Zenair Europe

Service Letter

S.L. Number:	ZE-2009-07																											
Date of issue:	December 4, 2009																											
Subject:	Airframe Upgrades for ULM versions of the CH 601 XL/CH 650E.																											
Affected Models:	All CH 601 XL/CH 650E models built and operated as ULM (MTOM of 450 kg +5%) as defined by LTF-UL standards (or similar).																											
Serial Number(s)	All affected models built by CZAW or assembled from a CZAW kit. All affected models assembled from a US-made kit, up to serial #6(5)-6890																											
Manufactured by:	Czech Aircraft Works (CZAW) and others.																											
Purpose:	To stiffen and strengthen the rear-spar channel, center spar section and cabin area of the aircraft, thereby also reducing the effect of non-linear vibrations that may occur if certain aircraft components are poorly built, inadequately maintained or damaged.																											
Directed Action(s):	<p>These upgrades include three (3) doublers per wing against to the rear spar channel, two (2) doublers affixed to the top and front of the center-spar, "Z" angle stiffeners on the cabin sides, and extra rivets thro

6Z-2G-1 TOP REAR CHANNEL ANGLE
t=.040" 6061-T6 (4 REQ'D)

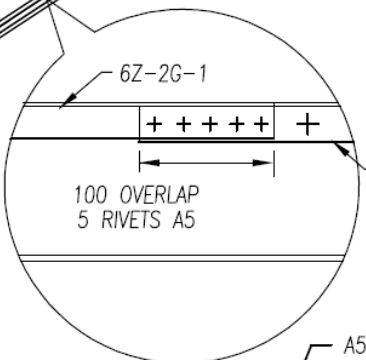
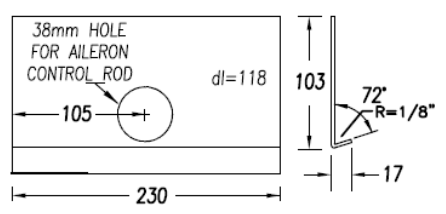
- 6Z-2G-1**
TOP FLANGE OF REAR CHANNEL IS DOUBLED ALONG FULL LENGTH WITH SPAR ANGLE 6Z-2G-1
OVERLAP EACH PIECE 100MM
- 6Z-2G-2**
ADD DOUBLER PLATE CENTERED ON HOLE FOR AILERON ROD.
- 6Z-2G-3**
REPLACE HINGE DOUBLER 6W7-3 WITH REAR DOUBLER 6Z-2G-3

6Z-4G-1 CENTER SPAR TOP DOUBLER
t=.063" 6061-T6 (1 REQ'D)

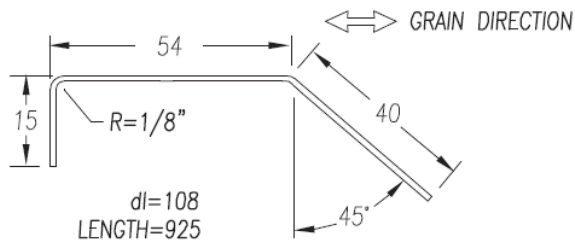
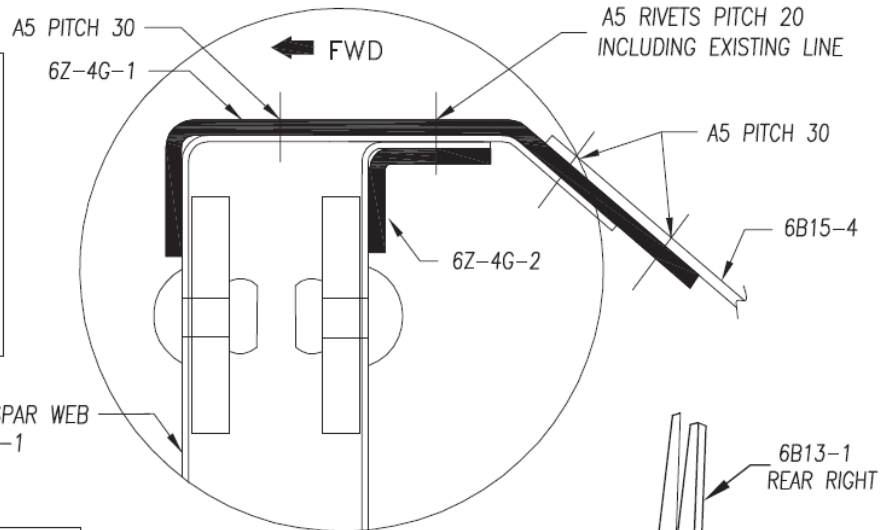
6Z-4G-1
REMOVE CENTER CONSOLE TO DRILL OUT EXISTING RIVETS ON TOP OF SPAR AND ALONG FRONT OF SEAT. CUT NOTCHES IN FRONT FLANGE OF 6Z-4G-1 TO MAKE ROOM FOR ENDS OF $\frac{3}{4}$ " EXTRUSIONS UPRIGHTS 6W4-4

ZODIAC CH 601 XL / 650E	ULM Fuselage Upgrades	6Z-4G
	Copyright© 2009 CHRIS HEINTZ	DATE: 30 NOV 2009

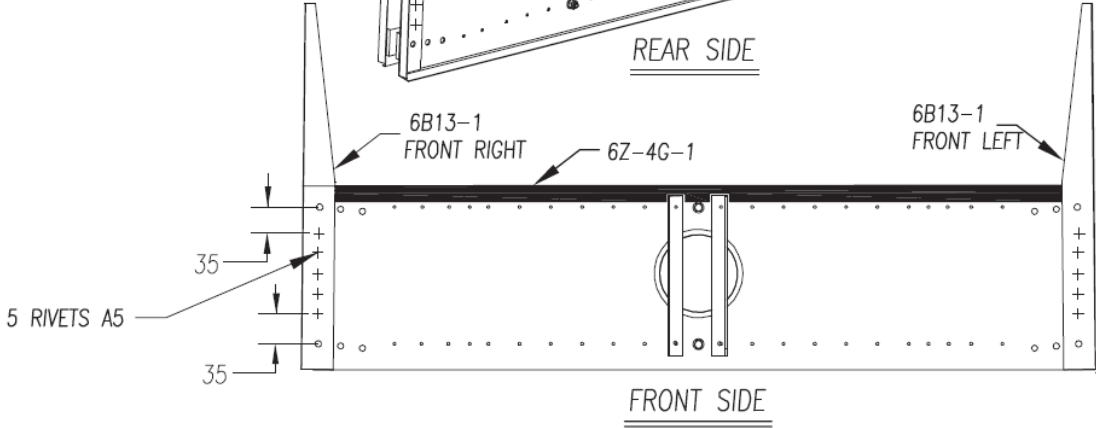
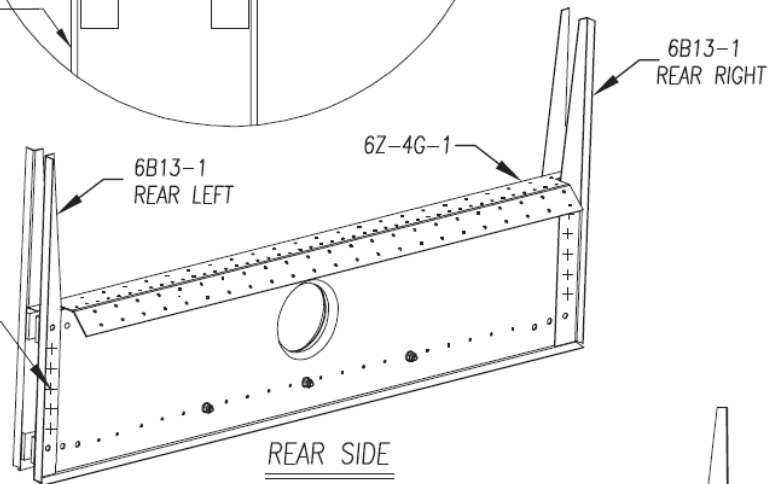
5 RIVETS A5
ADD 5 RIVETS A5 IN FRONT AND REAR WING ATTACHMENT UPRIGHTS 6B13-1
CAUTION: WHEN DRILLING RIVETS NOT TO DAMAGE WING SPAR WEB

6Z-5G-1 STANDARD Z ANGLE
t=.025" 6061-T6 (1 REQ'D)

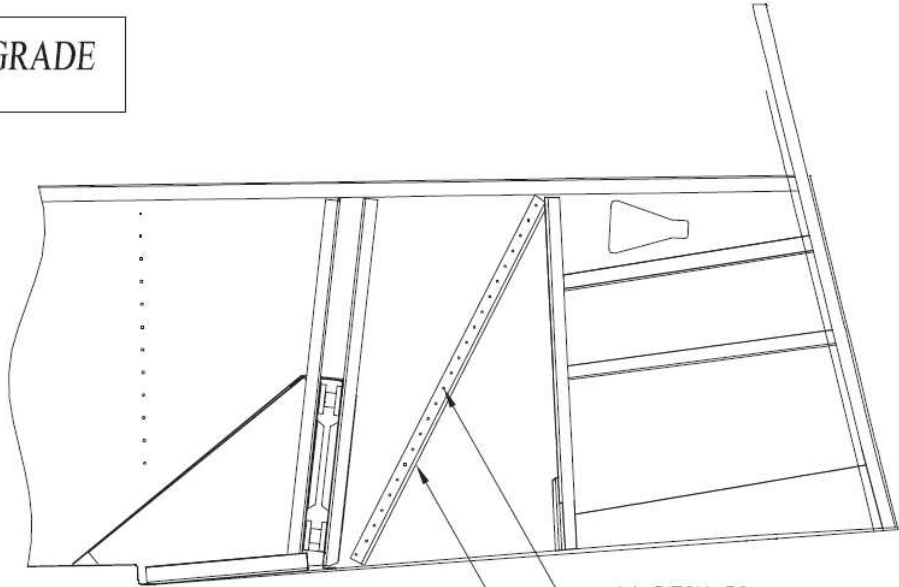
ADD A Z ANGLE A4 RIVETS PITCH 30
SET RIVETS ABOVE WING FROM THE OUTSIDE;
SET REMAINING RIVETS FROM INSIDE CABIN.

FLAP STOP CHECK

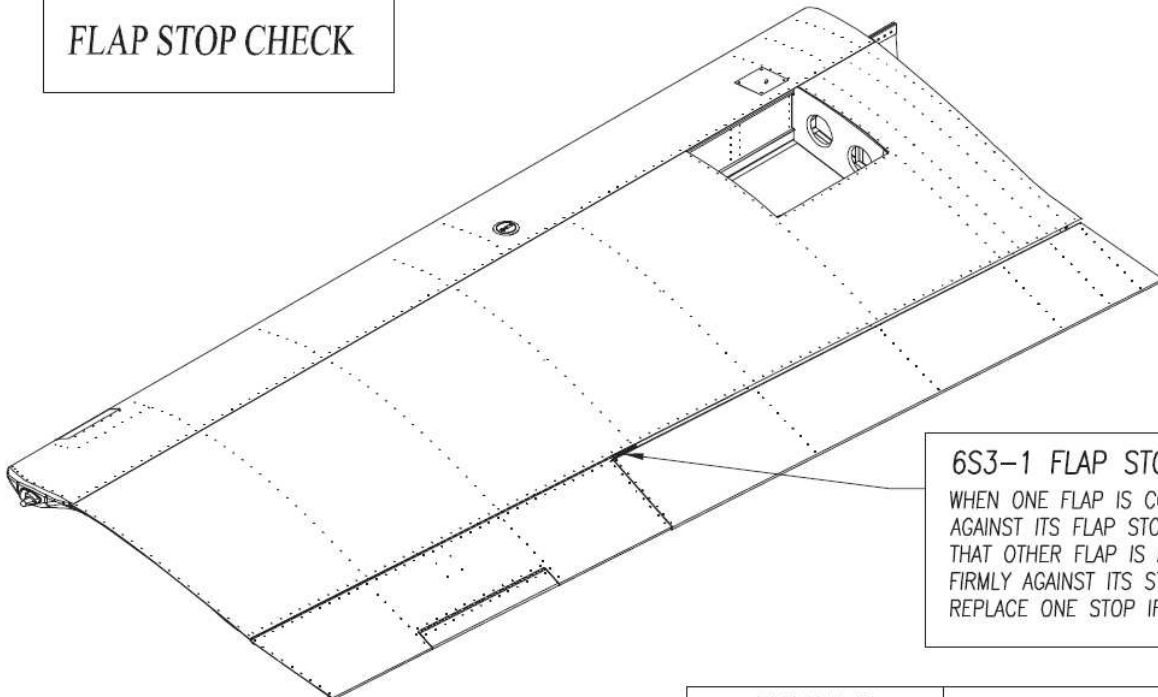
WHEN ONE FLAP IS COMPRESSED
AGAINST ITS FLAP STOP, CHECK
THAT OTHER FLAP IS ALSO PUSHED
FIRMLY AGAINST ITS STOP.
REPLACE ONE STOP IF NECESSARY.
